This Service Information bulletin supersedes S.I. B51 02 05 dated December 2006.

# **Squeaking Noise From Door Frame Area While Driving**

E60, E61 (5 Series)

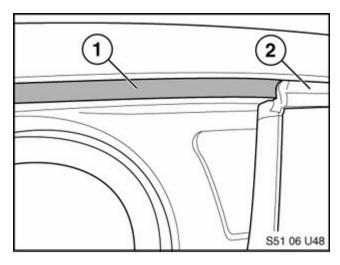
Apply a continuous length of Teflon tape

(PN 9 407 798) to the contact area of the flocking material (1) on the body of the vehicle.

The area where the tape should be applied to spans from the middle of the a-pillar to the rear-most point on the rear door opening as indicated by the arrows.

To eliminate visibility of the tape when the door is closed and ensure proper contact with the flocking surface, the upper edge of the tape (1) should line up evenly with the top of the door seal (2) for the entire length of the applied area. The tape should be applied in its full width (16mm), not be cut down to a narrower width.
